## RESPONSE TO REQUEST FOR ADDITIONAL INFORMATION

### APR1400 Design Certification

Docket No. 52-046

RAI No.: 52-7832  
SRP Section: 06.02.01.02 – Subcompartment Analysis  
Application Section: SRP 6.2.1.2  
Date of RAI Issue: 06/23/2015

**Figure 6.2.1-24 Sectional View and Nodal Model of the Regenerative Heat Exchanger Subcompartment**

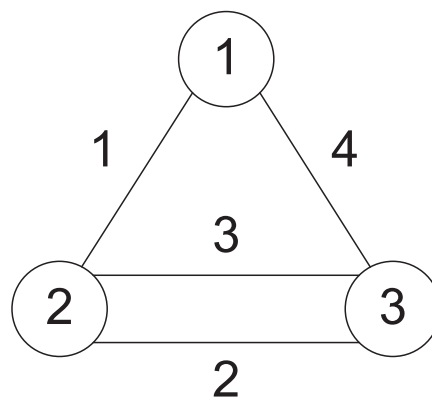
The nodalization for the regenerative heat exchanger subcompartment (DCD Tier 2, Figure 6.2.1-24) is not clear. The room is described as having only one access point that interacts with the containment atmosphere in DCD Tier 2, Section 6.2.1.2.2, but is modeled as attached to a second room with access to two additional containment access points. Clarify in the description of DCD Tier 2, Section 6.2.1.2.2 how the regenerative heat exchanger subcompartment is modeled, including a description of the in-core instrumentation (ICI) chase. The staff needs this information to make a finding that the pressure calculation performed shows a reasonable assurance that design pressures will not be exceeded.

Two access openings to the corridor are modeled as vent paths from nodes 2 to 3 in two directions: one is toward the north and the other is toward the south. One vent opening is modeled as a vent path from nodes 1 to 3.

The designation for node 2 will be changed from "Access Area to the ICI Chase" to "Corridor below Regenerative Heat Exchanger Subcompartment".

DCD Tier 2, Subsection 6.2.1.2.2 and Figure 6.2.1-24 will be revised as indicated in the Attachment.

Node 2: ~~Access Area to the ICI Chase~~

Corridor below Regenerative Heat Exchanger Subcompartment
